ECE/TRANS/WP.29/2006/4  
12 December 2005

PROPOSAL FOR SUPPLEMENT 4 TO THE 02 SERIES OF AMENDMENTS  
TO REGULATION No. 51

(Noise emissions)

Transmitted by the Working Party on Noise (GRB)

Figure 1

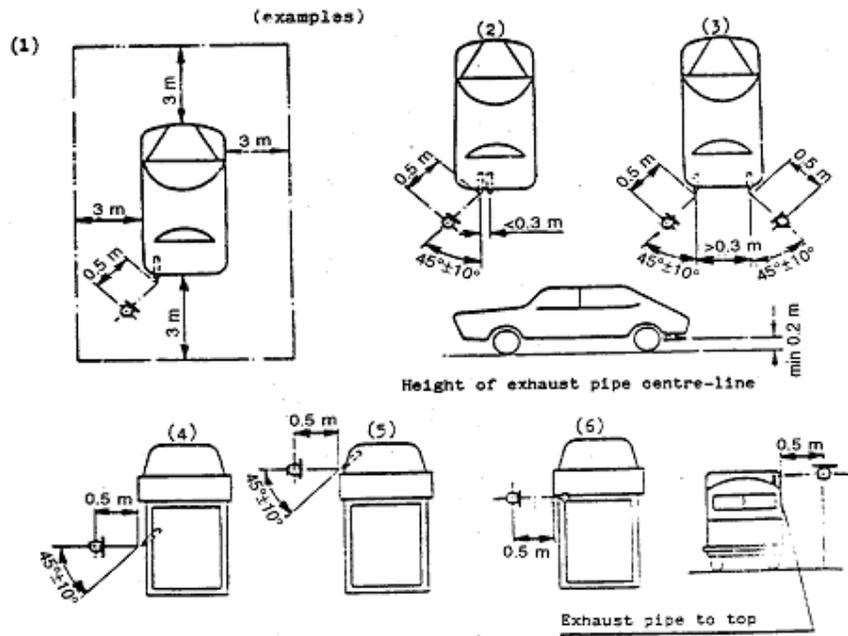
3.2.5.3.1.2. The microphone shall be located at a distance of  $0.5 \text{ m} \pm 0.01 \text{ m}$  from the reference point of the exhaust pipe defined in Figure 1, and at an angle of  $45^\circ (\pm 5^\circ)$  to the flow axis of the pipe termination. The microphone shall be at the height of the reference point 1/, but not less than 0.2 m from the ground surface. The reference axis of the microphone shall lie in a plane parallel to the ground surface and shall be directed toward the reference point on the exhaust outlet. If two microphone positions are possible, the location farthest laterally from the vehicle longitudinal centreline shall be used. If the flow axis of the exhaust outlet pipe is at  $90^\circ$  to the vehicle longitudinal centreline, the microphone shall be located at the point, which is farthest from the engine.
